SERVICE BULLETIN

ENGINE - HP COMPRESSOR - STAGE 8 AND 11 REAR INNER CASING HEATSHIELDS WITH CORROSION PROTECTION - CATEGORY CODE 6 - MOD.ENG-72-0034

V2500-ENG-72-0034

Location of heatshields
Fig.1

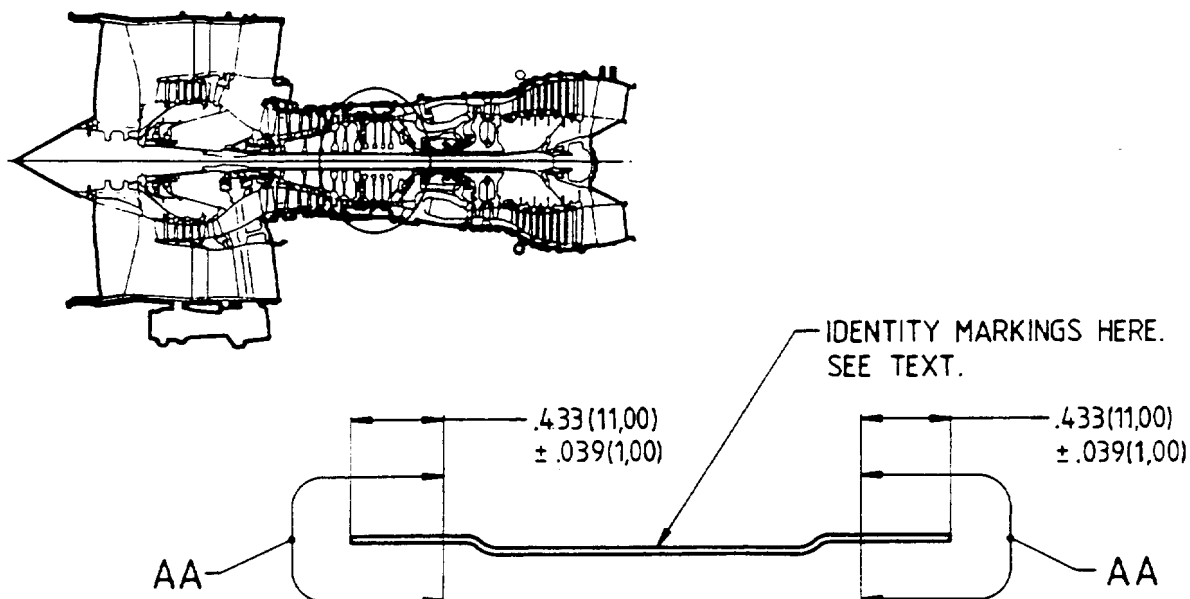
- (1) Rework 6A3020, stage 8, heatshield and 6A3021, stage 11, heatshield.
(Refer to 72-41-21, Fig./Item 03-900 and 04-520).

Typical section thru heatshield assembly - Stage 11
Fig.2

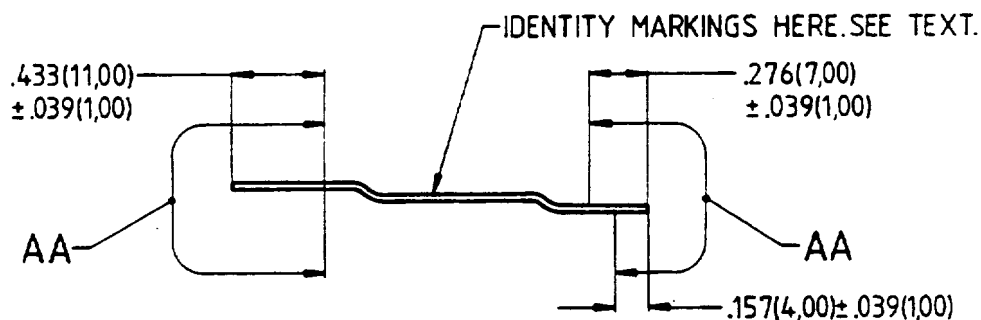
APPLY THE HIGH HEAT RESISTING ENAMEL AS GIVEN IN TEXT.

DO NOT LET THE ENAMEL TOUCH THE AREAS SPECIFIED AA.

REWORKING OF EXISTING HEATSHIELD ASSEMBLIES—STAGES 8 & 11.

- (a) The stage 8 and 11 rear inner heatshields are coated all over except for abutment areas, with heat resisting enamel.
